[Docket No. 2002-SW-38-AD; Amendment 39-12935; AD 2002-22-10]

Airworthiness Directives; Bell Helicopter Textron Canada Limited Model 407 Helicopters

ACTION: Final rule; request for comments.

Figure 1. Pre-Flight check of brackets, horizontal stabilizer slats.

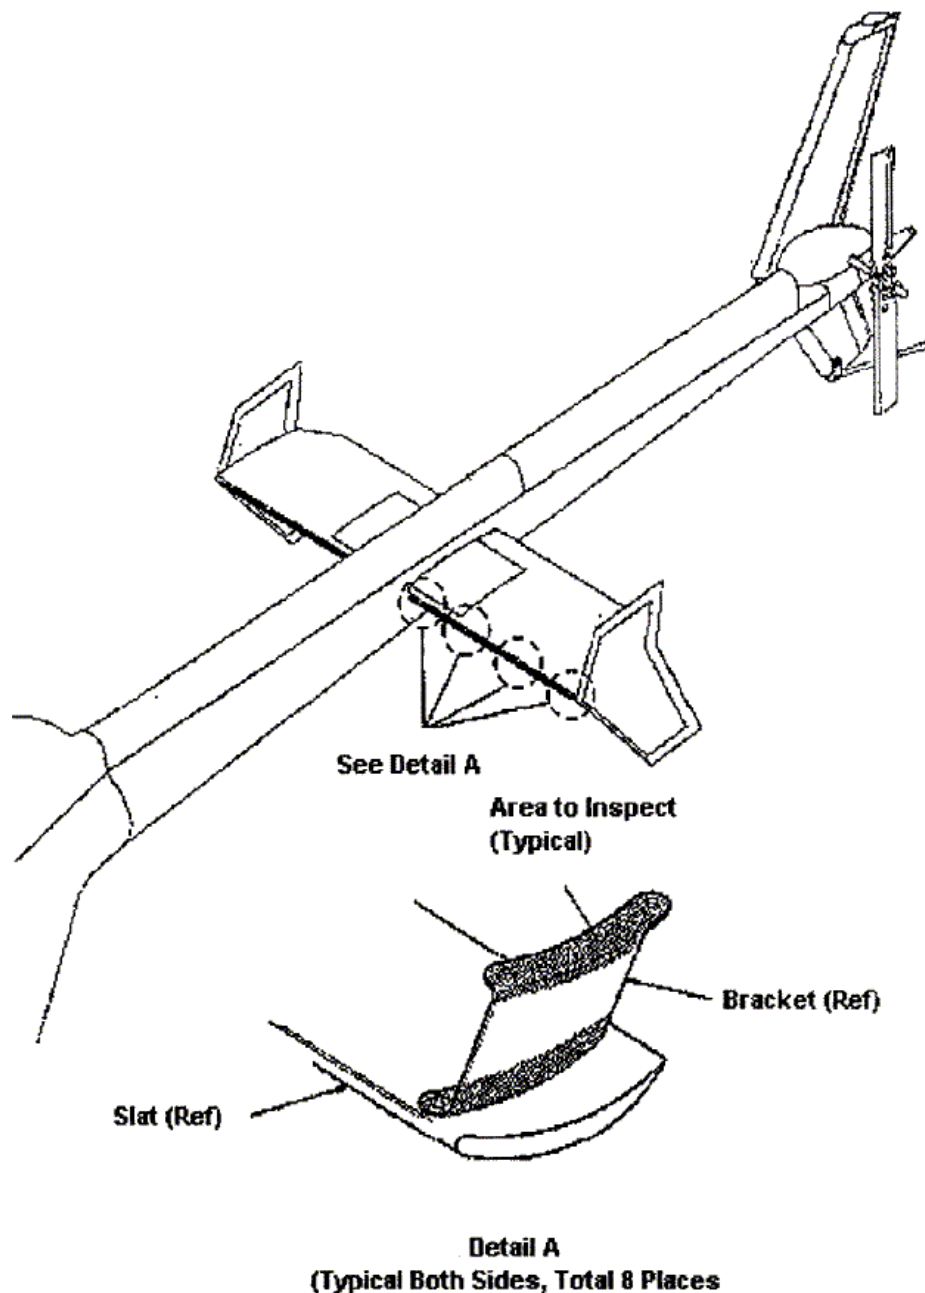
(1) Within 10 hours time-in-service (TIS) and thereafter before the first flight of each day, check each slat for a crack at the radius of each bracket, part numbers (P/N) 206-023-119-109, -110 or 407-023-801-127, -128, or 407-023-001-119, -120, or -121, as shown in Figure 1 of this AD:

(3) If a crack is found, before further flight, replace slat assembly, P/N 407-023-002-117 or 407-023-001-101, with an airworthy, segmented slat assembly, P/N 407-023-001-103.

(4) Replacing slat assembly, P/N 407-023-002-117 and 407-023-001-101, with an airworthy, segmented slat assembly, P/N 407-023-001-103, is terminating action for the check required by paragraph (a)(1) of this AD.
